Avolites LTD Engineering Change Notice

ECN title	QTZ LEDs remain on		
ECN Number	ECN-0216		
Related Product(s)	QTZ		
Date / Author	14/11/2022	GK	
Reasons for ECN	When console powers down, the fader LEDs remain on		
Parts required	06-03-0264 - CAP. SMD 10uF, MLCC 1206		
Tools required	PZ2 driver, Solder iron		
Estimated time	10 minutes

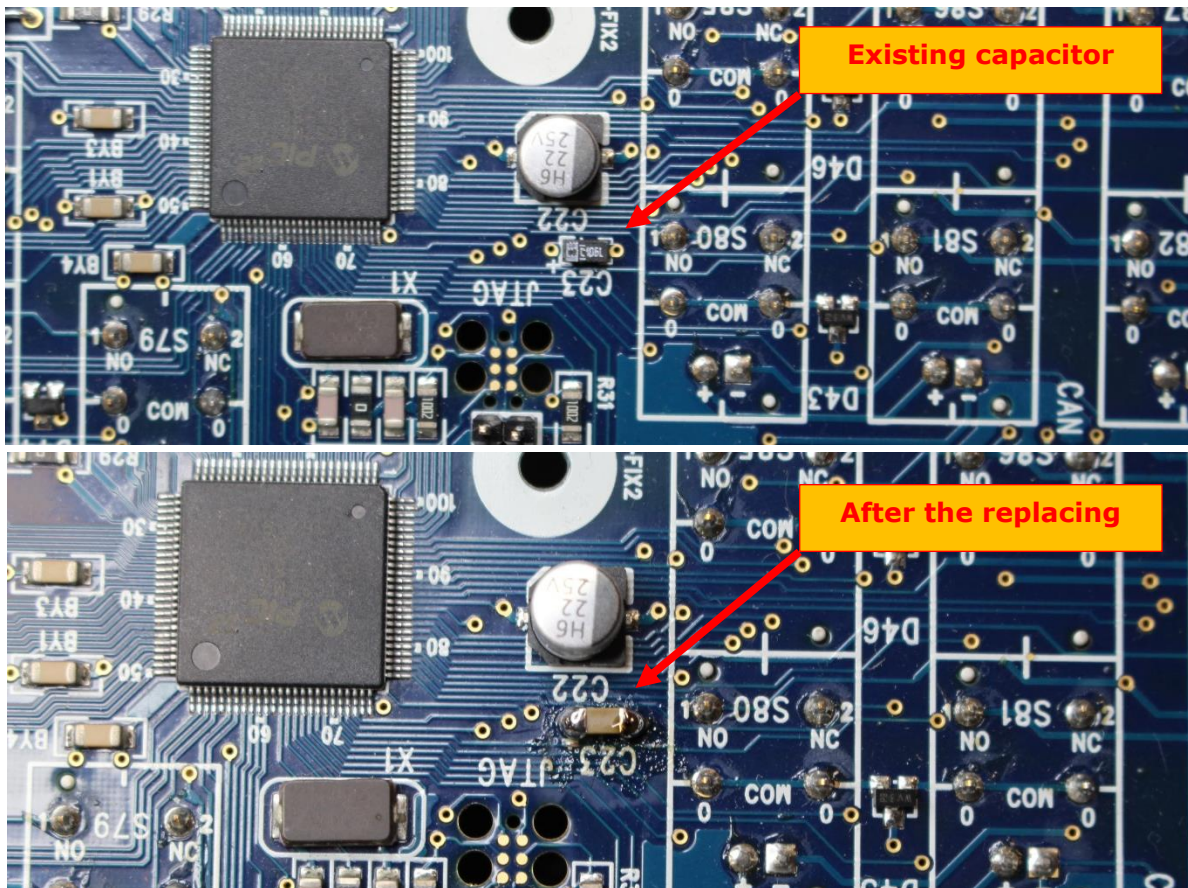
We have had a case of when console powers down, the fader LEDs remain on.

Replace existing C23 capacitor with the supplied one (06-03-0264 - CAP. SMD 10uF, MLCC 1206)
